TSB110277

Signature™, QSX, and ISX CM570/CM870/CM871/CM2250 Replacement Cylinder Liner Compatibility

Figure 1, Location of Measurement

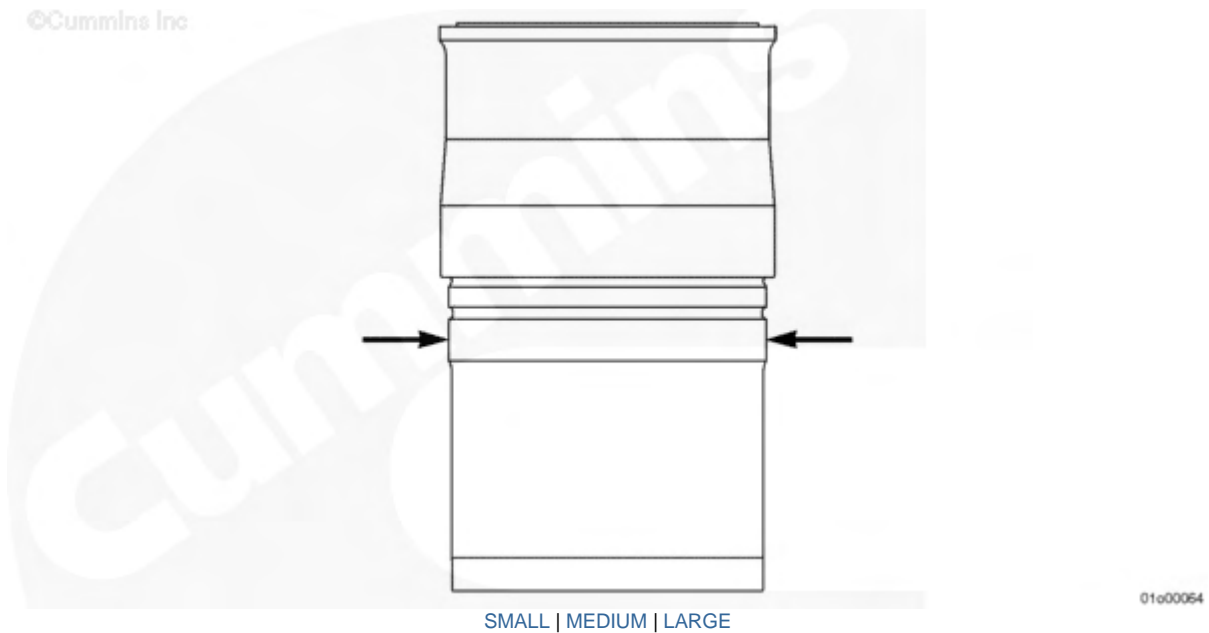
Before replacing a flat top designed cylinder liner, verify the size of the cylinder liner presently installed on the engine. The correct cylinder liner can be determined by measuring the outside diameter of the cylinder liner at the cylinder liner o-ring packing area. For a groove top design cylinder liner, the verification is **not** needed when replacing a groove top cylinder liner with another groove top cylinder liner. See Figure 1 for the location where the measurement is to be taken.

NOTE: A small outside diameter cylinder liner will visually appear to have been correctly installed into a large bore cylinder block. However, because of the smaller outside diameter of the cylinder liner, it will fit loosely into the cylinder block at the cylinder liner o-ring sealing area. This will result in excessive cylinder liner movement in the cylinder block.

Once the size of the cylinder liner has been determined, refer to the table below for the correct cylinder liner part number.

Cylinder Liner and Kit Part Number		
Liner Outside Diameter (OD)	Cylinder Liner	Cylinder Liner Kit
150 mm [5.906 in]	4311633	4309389
152 mm [5.984 in]	3685235	2881719
